STAFF ANALYSIS

Case No.: Z-20-1244108 Agenda #: N. 3

Rezoning of property from the C-1 (Local Commercial) and the C-2 (General Commercial)

Request: districts to the HR-3 (High Density Residential-3) district to allow for the construction of a

REZONING SITE PLAN

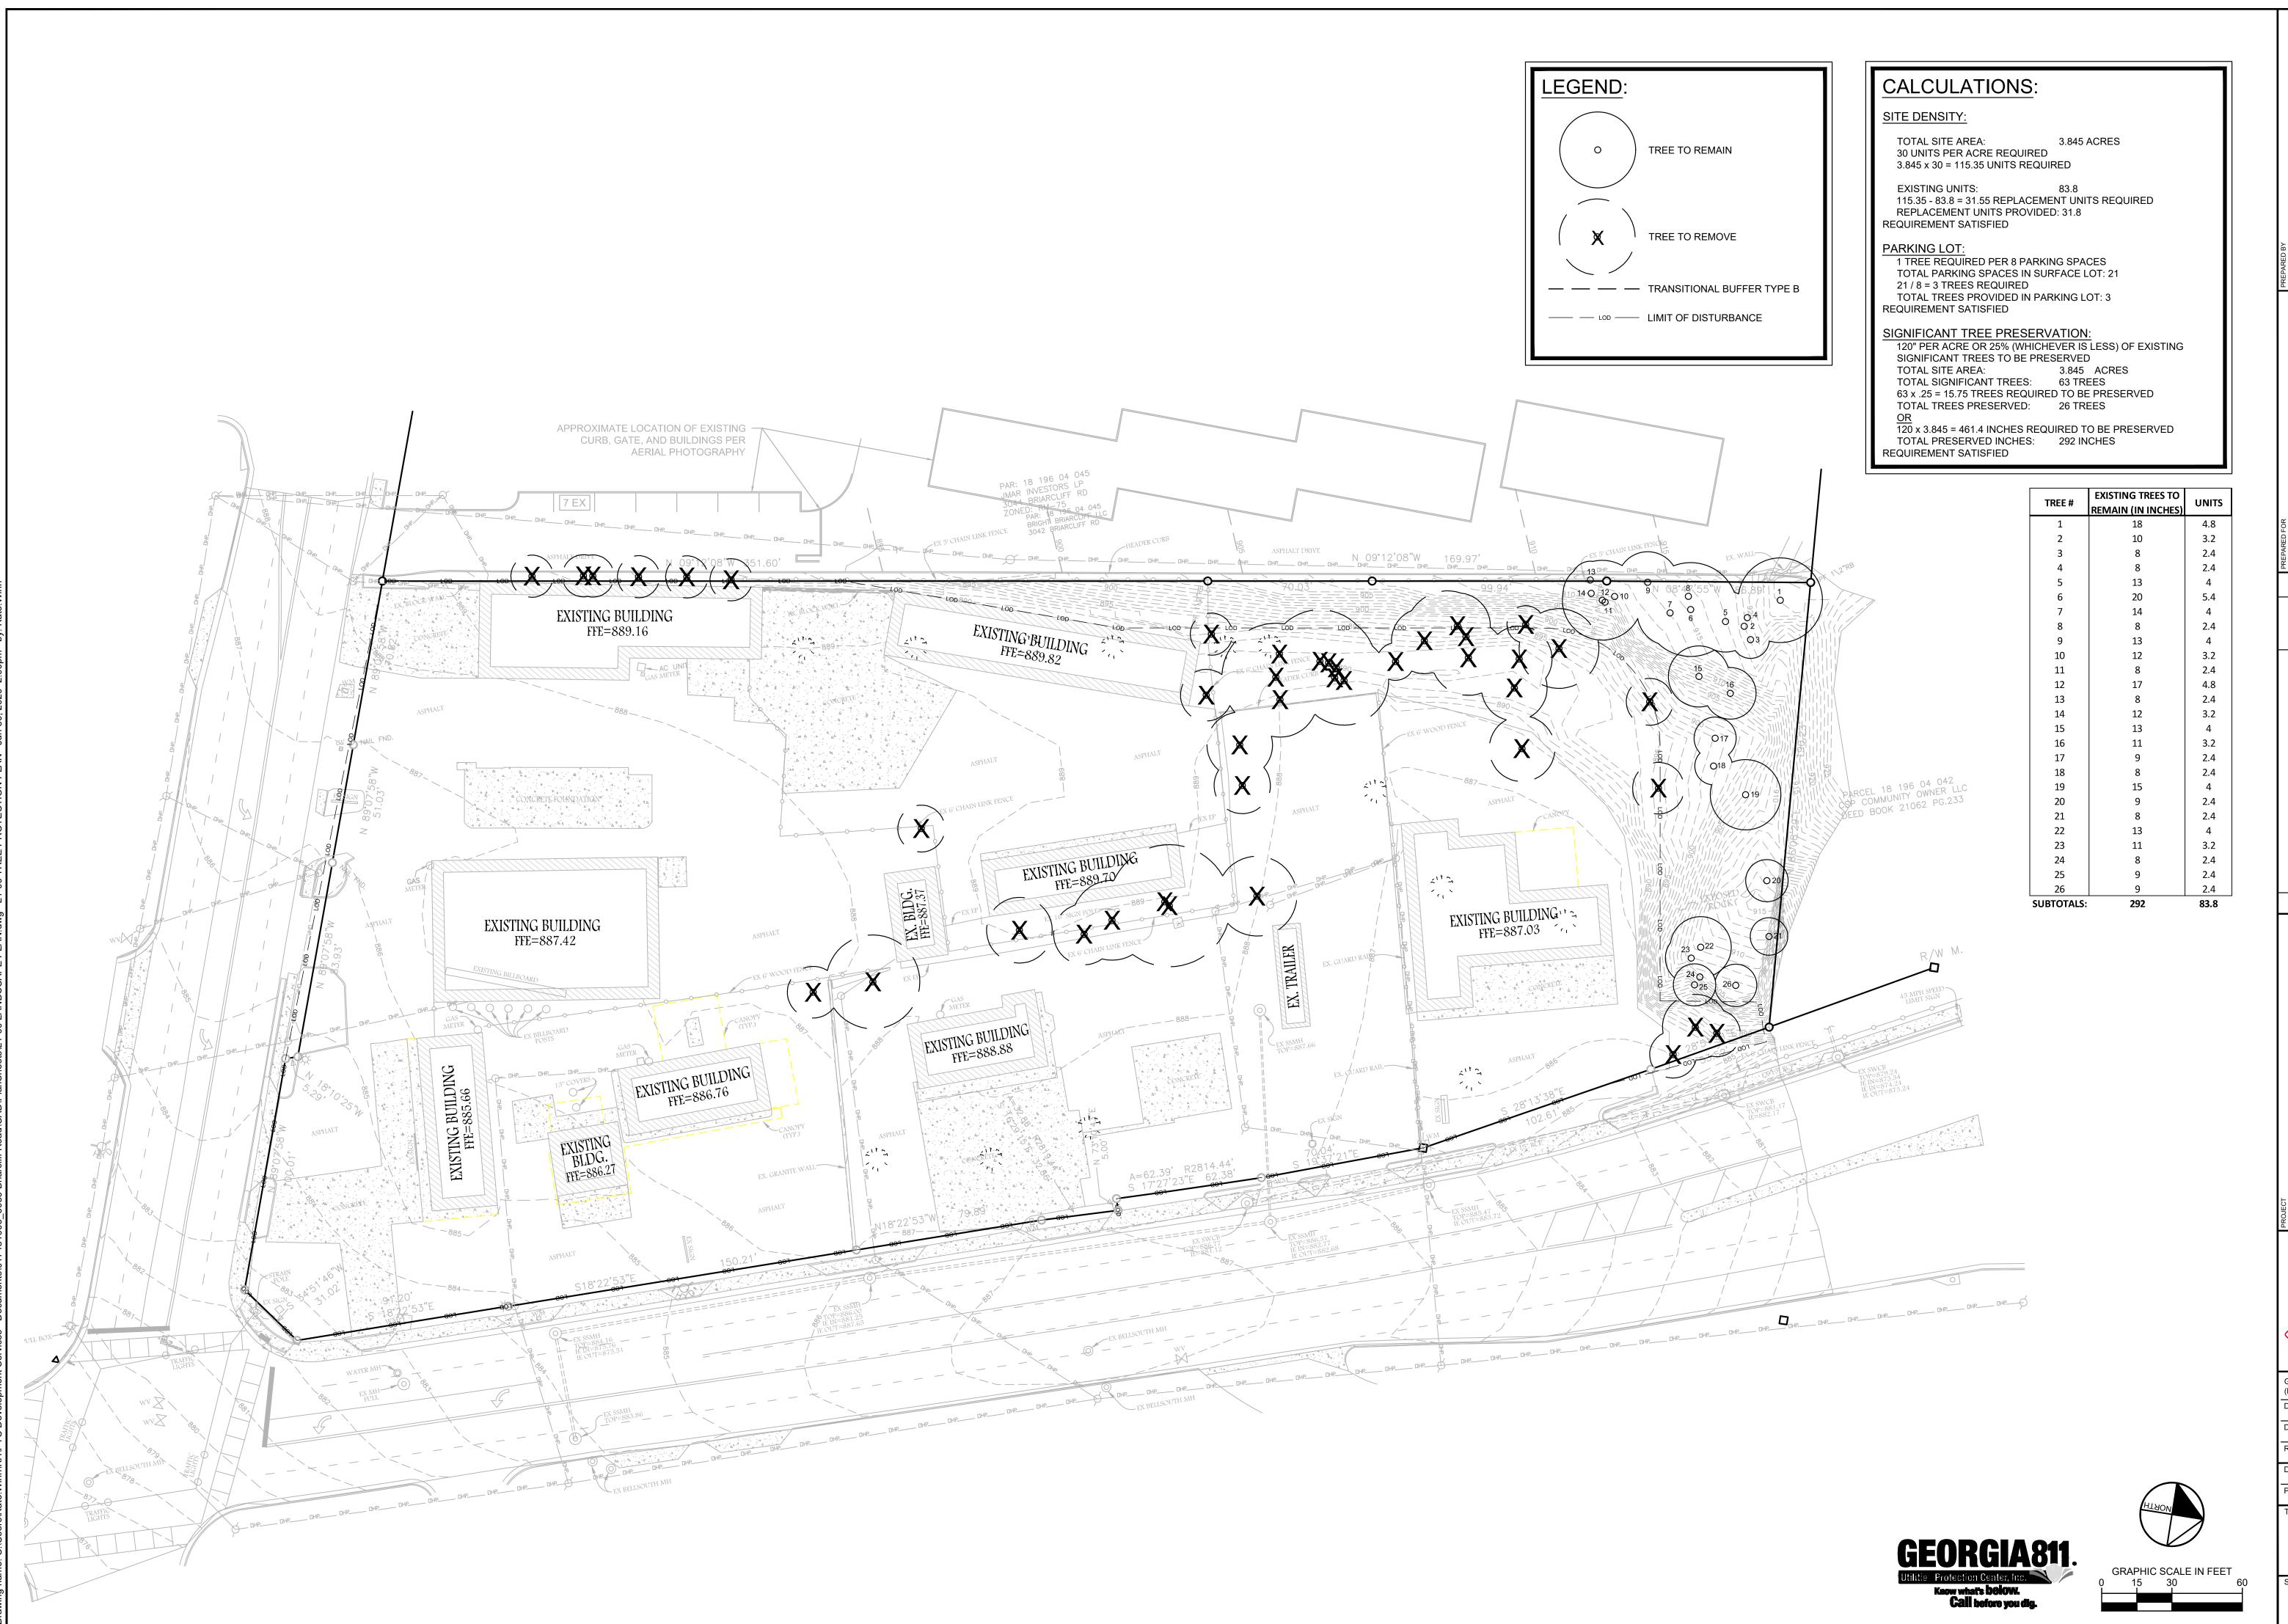
The site plan shows bike lanes along both Clairmont and Briarcliff Roads. In addition, streetscaping is provided along both frontages, consisting of landscape strips back of curb, planted with street trees, and sidewalks six to eight feet wide.

The property line will move if the Clairmont Road and Briarcliff Road rights-of-way are relocated as indicated on the site plan, making the buildings non-compliant with the minimum HR-3 setbacks of 10 feet. In addition, the proposed number of residential parking spaces is 26 spaces less than the required minimum; the number of commercial spaces is eight spaces less than the minimum. Landscape strips are 4-8 feet narrower than required.

The site plan depicts provision of the required sidewalks and bike lanes along both Briarcliff Road and Clairmont Road.

SIDE - CORNER LOT	(Clairmont Road): Minimum 10 feet Maximum 20 feet	Before road widening – 18.5 ft.; After road widening 2 ft.;	Yes After road widening, a variance will be needed.
	REAR W/O ALLEY	MF & MU:20 ft. CM/OF/MU: 15 ft.	20 feet	Yes
